**DA21/0945 – PPSSWC-214**  
**180 Great Western Hwy & 26 Rodgers St, Kingswood**  
**Proposed Mixed Use Development**  
**Adequacy of Proposed Pub Parking Provision**

As requested, I have undertaken a review of the Peer Review prepared by EMM Consulting, dated 15 May 2023, which was commissioned by the Sydney Western City Planning Panel (SWCPP) as part of the abovementioned development application (DA). In the view of the author of the Peer Review, there were a number of matters that were not adequately addressed in the DA package or needed further information/clarification.

Growth of Ubers by age group (Dec 2016 vs Dec 2018)

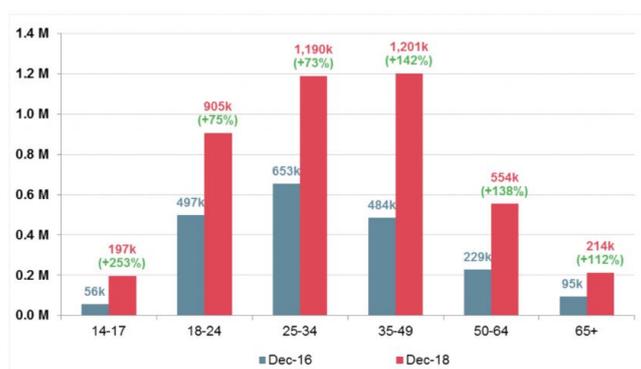
Reference to <https://thenewdaily.com.au/finance/consumer/2019/04/30/uber-ride-share-taxis-australia/> indicates that the number of Australians who travelled by Uber in an average three month between December 2016 and December 2018, more than doubled in percentage terms over that two year period, rising from 10.6% of the population to 20.8% of the population, as indicated in the graph extract below.

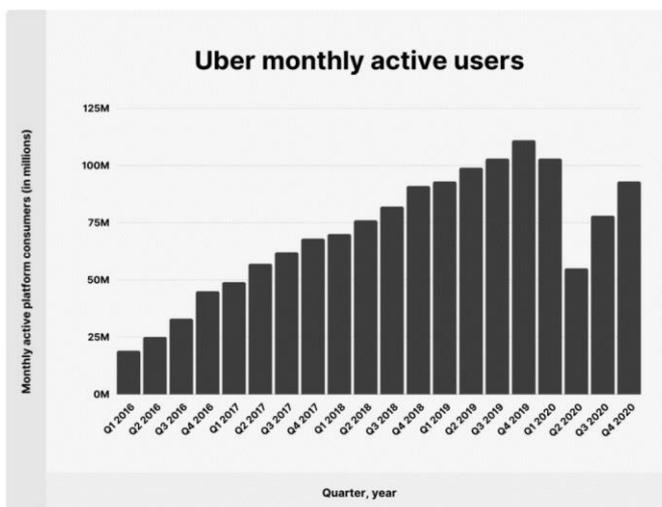
Reference to [www.backlinko.com/uber-users](http://www.backlinko.com/uber-users) also indicates that in the US, monthly active users of Uber steadily rose between the start of 2016 and the end of 2019, as indicated in the graph extract below. The drop off in the graph in 2020 is obviously related to usage during the Covid-19 pandemic, however, the graph indicates that usage in the US is steadily increasing again.
